Project	IEEE 802.16 Broadband Wireless Access Working Group < http://ieee802.org/16 >	
Title	Definition of the process for Adaptive Channel Selection	
Date Submitted	2006-02-28	
Source(s)	Wu Xuyong, Zhao Quanbo, Pan Zhong, Huawei Huawei Industrial Base, Bantian, Longgang, Shenzhen 518129 P.R.C	Voice: +86-755-28971677 Fax: +86-755-28975523 wuxuyong@huawei.com
Re:	80216h-06_005: Call for Comments and Contributions: IEEE 802.16 License-Exempt Task Group (2006-02-06)	
Abstract	In order to collect the information from all the influenced BS nearby, IBS need to scan all the channel and broadcast the contact information in all the candidate channel. After collect the necessary information, BS need to start negotiate with the neighbors when necessary. Updating the information during operation is still open and not the main purpose of this paper.	
Purpose	Conform the process for ACS for IBS according to all the current material in the WD.

Definition of the process for Adaptive Channel Selection Huawei Technologies Co., Ltd.

Figure h17—Initialization procedures — BS

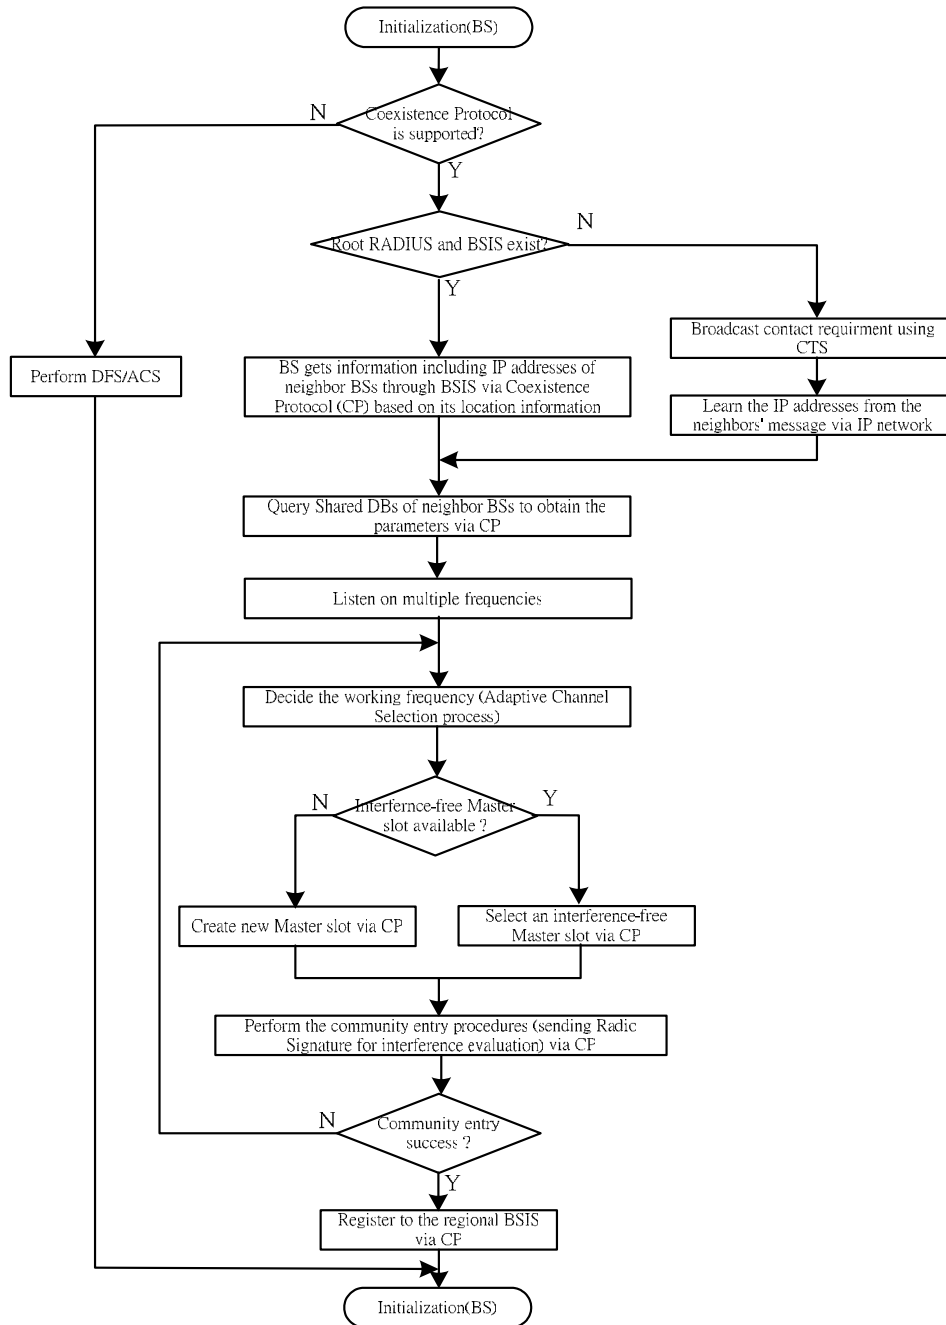
the following diagram figure h17 in 15.2.1.3 need to be change.

To clarify the description of initialization procedure, the resource allocation and CP messaging procedure should be defined separately.

Figure h17a—Initialization procedures — BS radio resource allocation

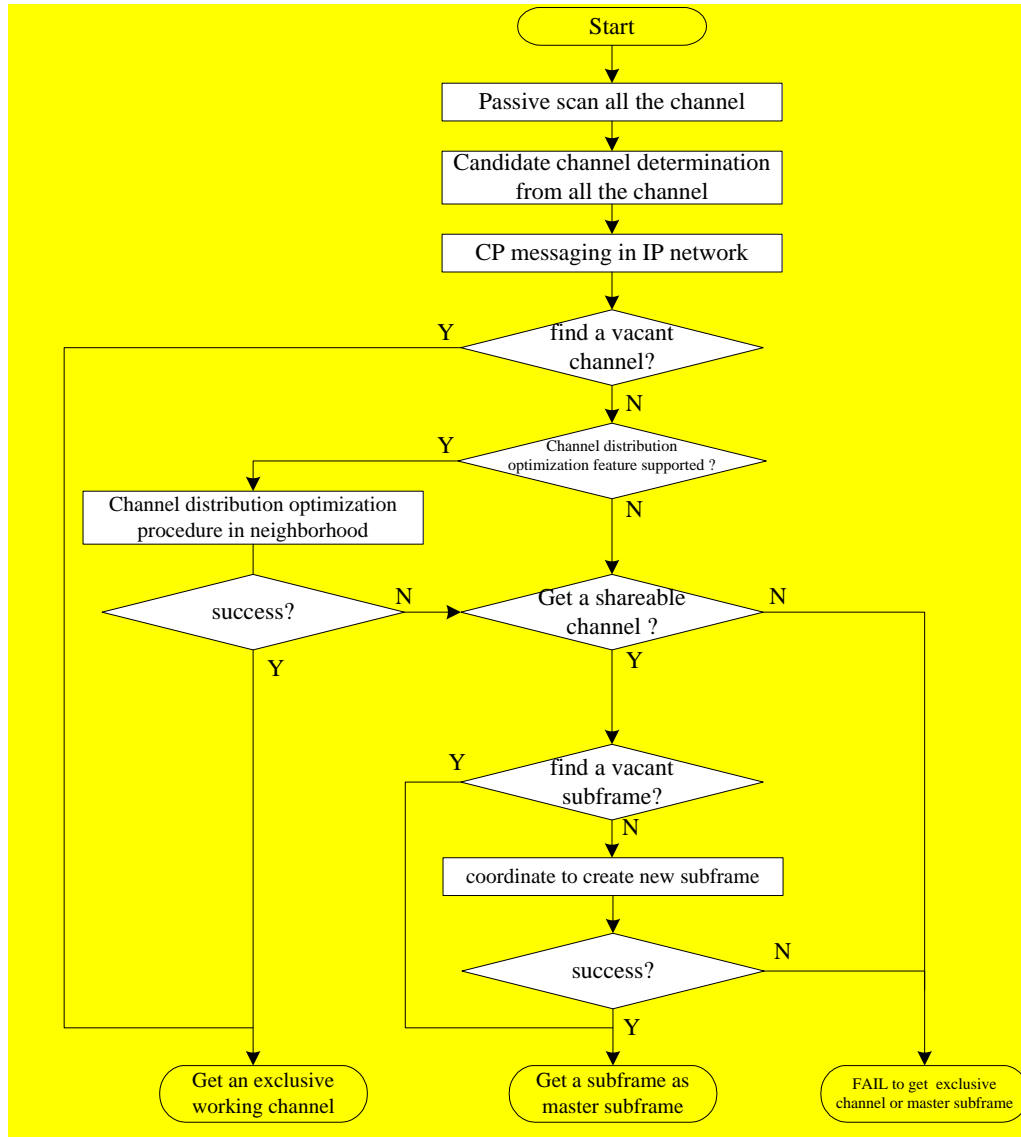
insert the Figure h17a after Figure h17 in 15.2.1.3 as indicate:
